Subject: AP1000 Responses to Requests for Additional Information (SRP 5)

AP1000 TECHNICAL REPORT REVIEW

RAI Response Number: RAI-SRP5.4.6-SRSB-01

Figure 14: Pressurizer Pressure

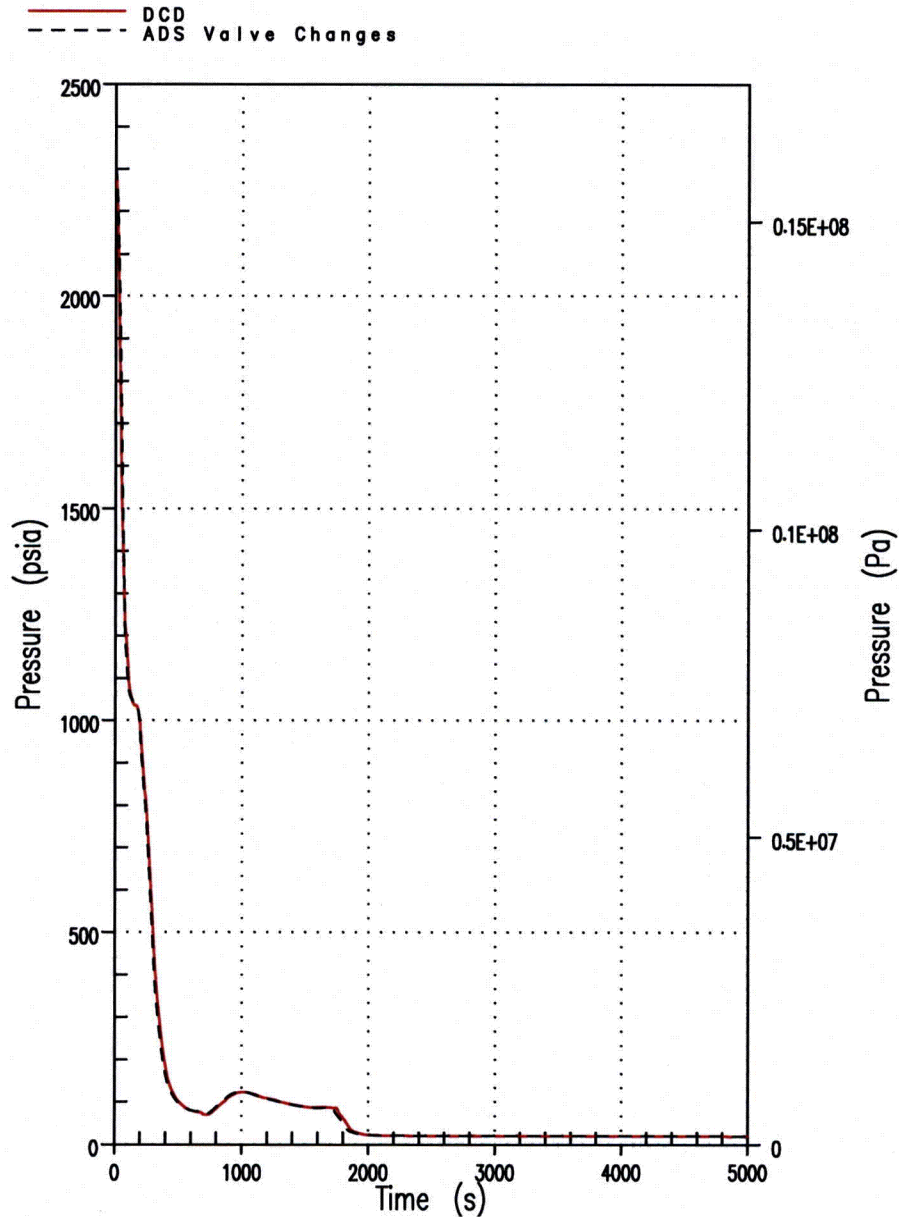
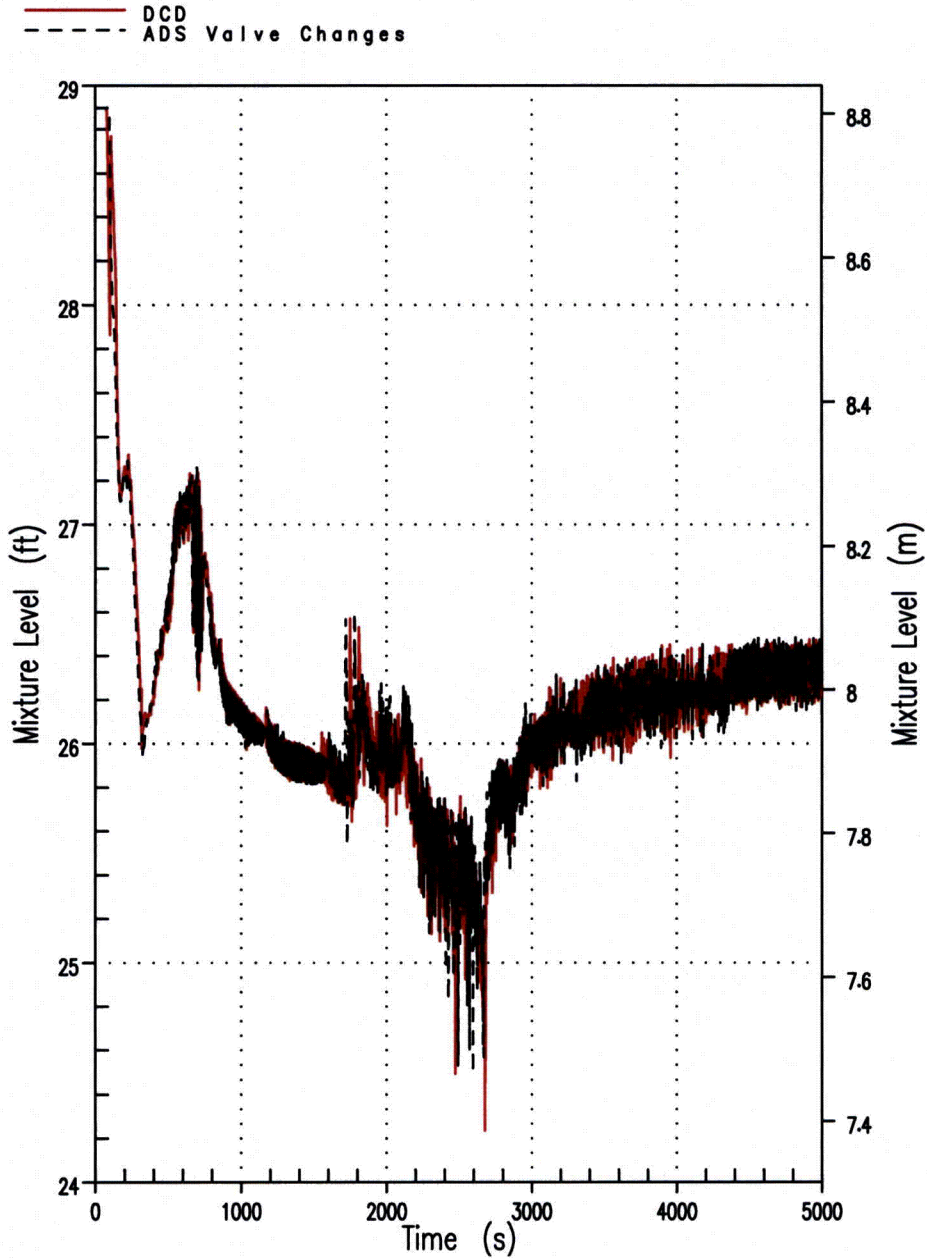
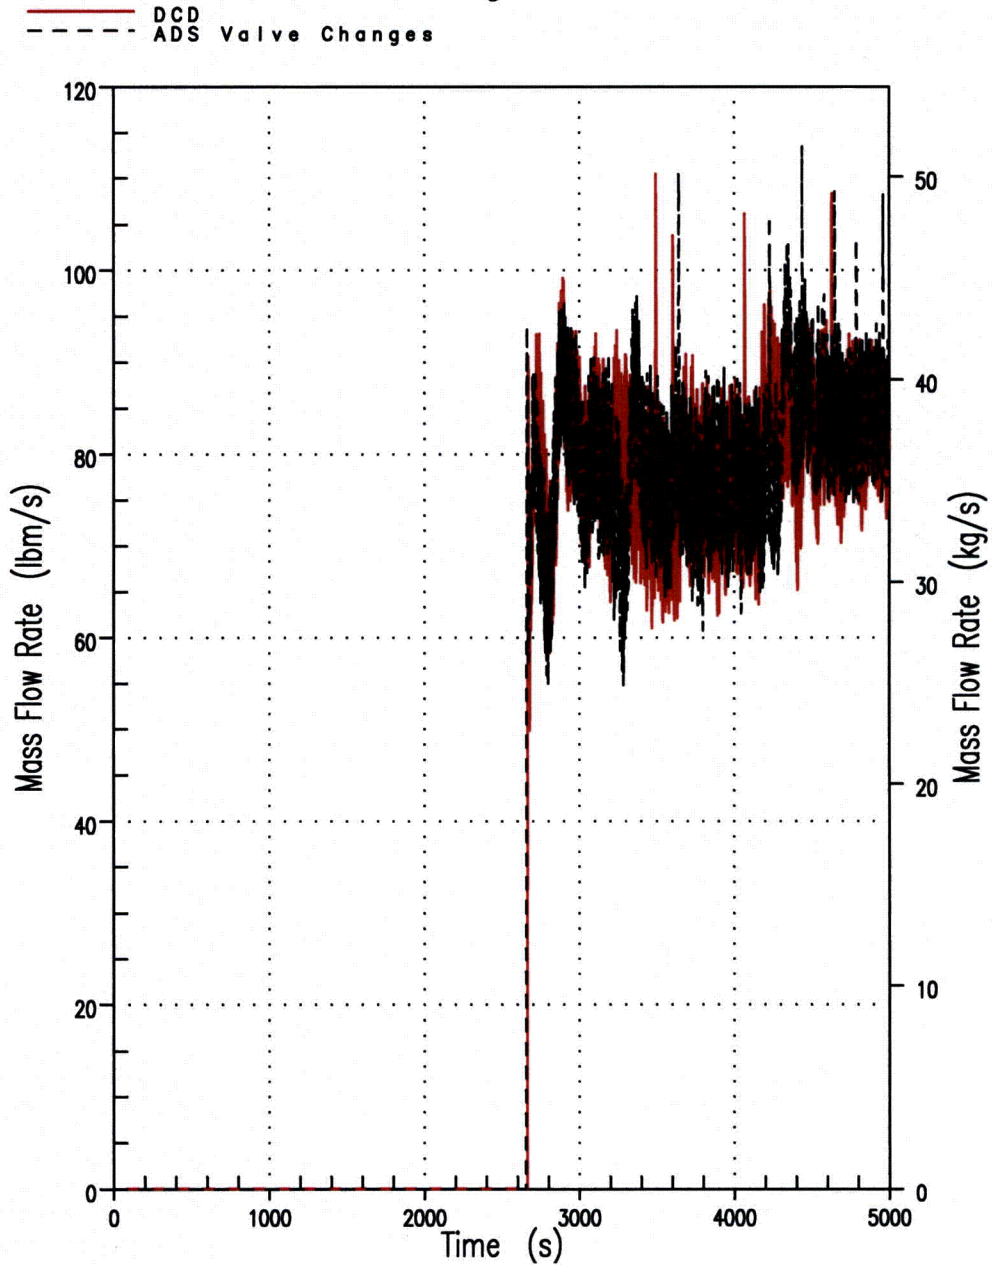
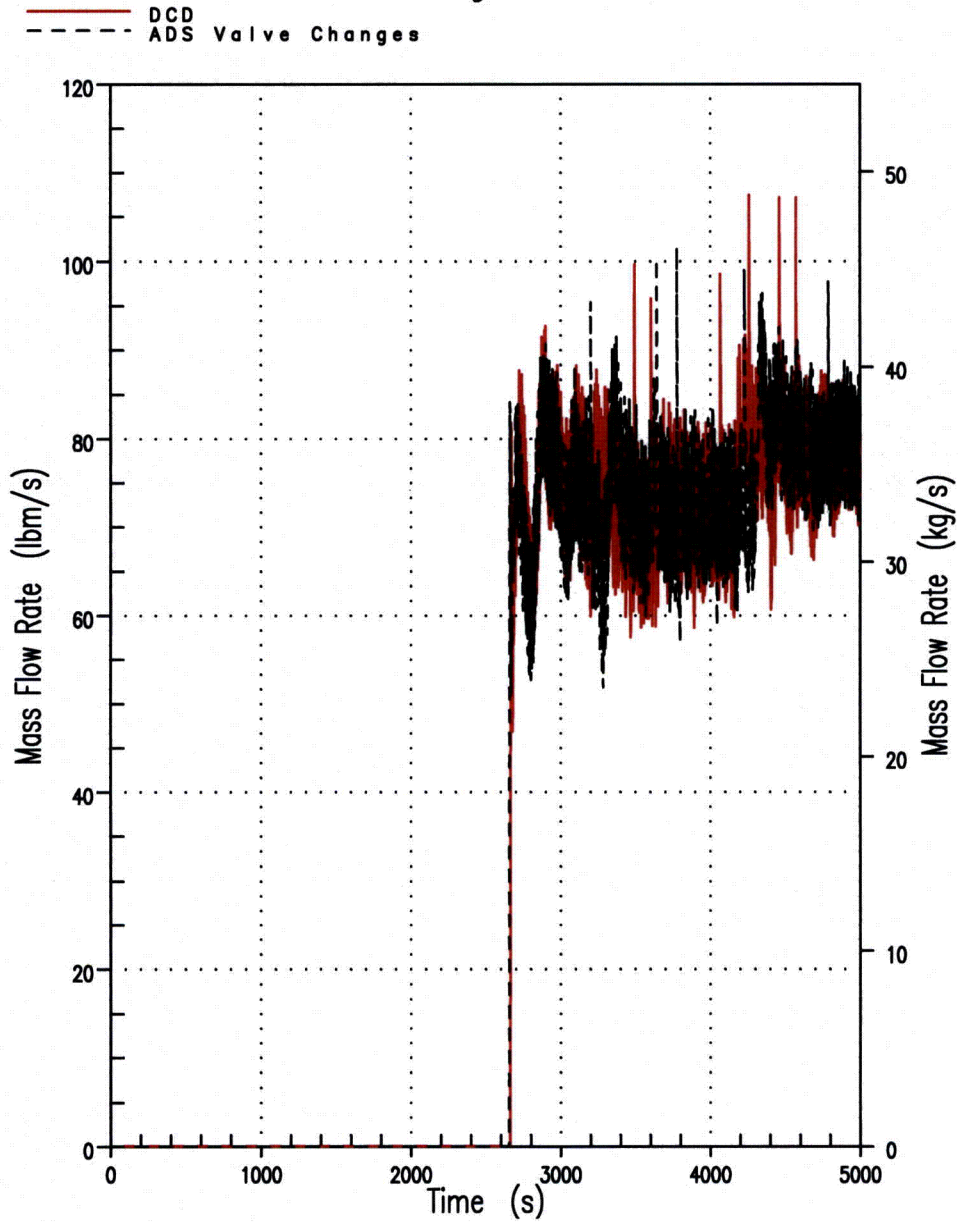
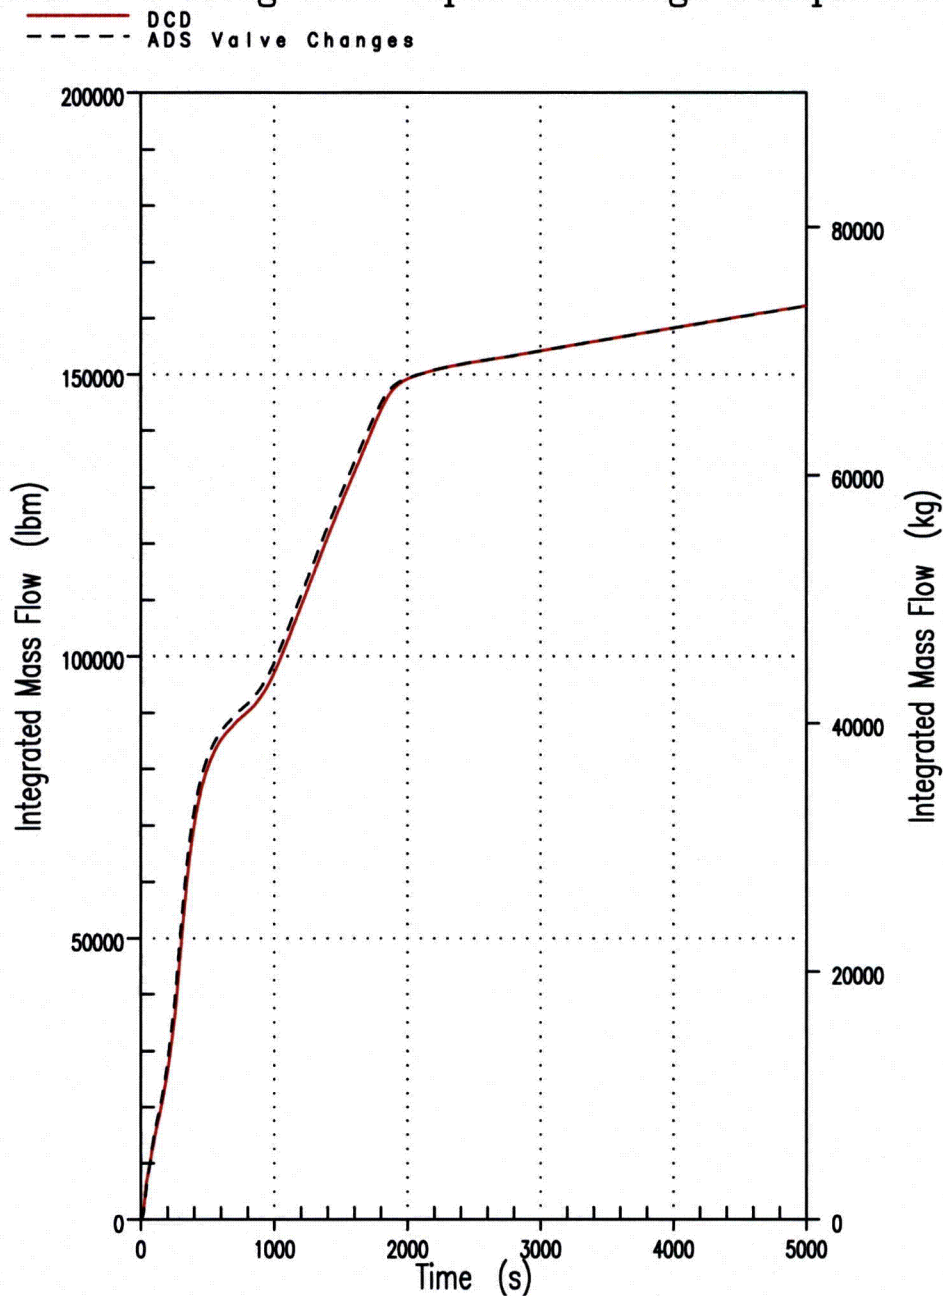
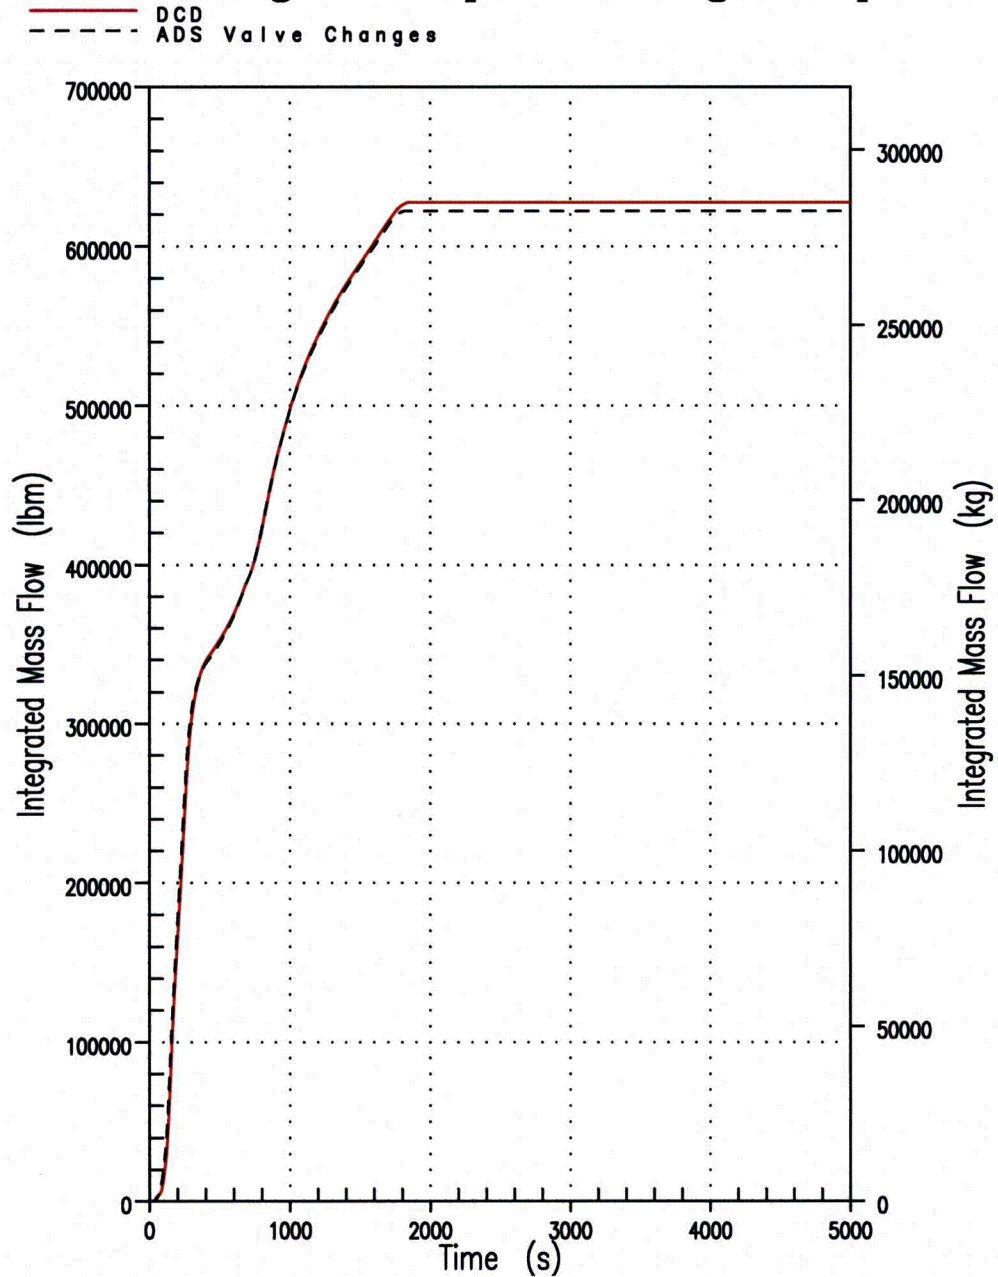
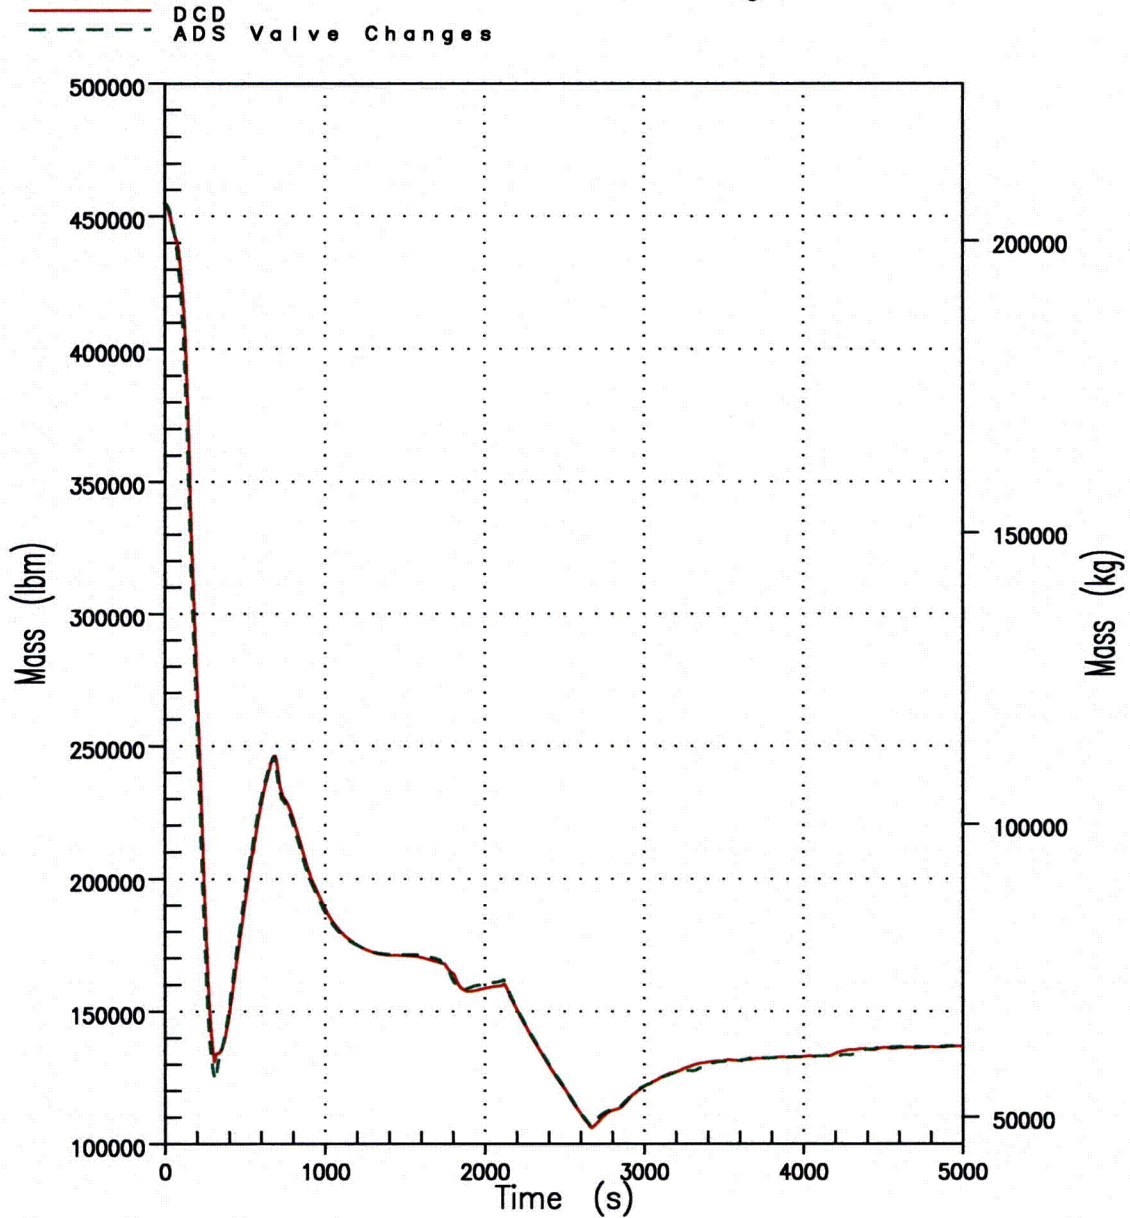
In Revision 17 to DCD, Tier 1 Table 2.1.2-4, Inspection, Tests, Analyses, and Acceptance Criteria (ITAAC), item 11.b, the acceptance criteria for the opening times (after receipt of signal from the PMS) of the remotely operated automatic depressurization system (ADS) stages 1, 2 and 3 valves (RCS-PL-V001A/B, V002A/B, V003A/B, V011A/B, V012A/B, and V013A/B) have been changed to longer times. Westinghouse AP1000 – DCD Revision 17 Changes Matrix indicates that the stroke times for these valves are modified to match actuator capacity.

Explain whether the changes of the ITAAC acceptance criteria of these ADS valve stroke times are consistent with the assumptions of the ADS valve opening time delay and stroke time assumed in the Chapter 15 safety analyses, and describe the effects of these changes on the safety analysis results of the events that result in the ADS actuation, such as small break loss-of-coolant accidents.

The third case analyzed for sensitivity to ADS valve stroke time increase is an Inadvertent Actuation of the ADS. Table 3 displays the major sequence of events and compares with the results of the case with increased ADS valve stroke times to the reference transient presented in the Design Control Document (DCD), Rev. 17. Figures 15-21 show the comparison between the two cases. Once again there doesn't appear to be any discernible difference between the two cases. Pressurizer pressure, core mixture level, and RCS inventory remain unchanged throughout the 5000 second transient. The conclusion that there is no core uncover for this case remains valid.
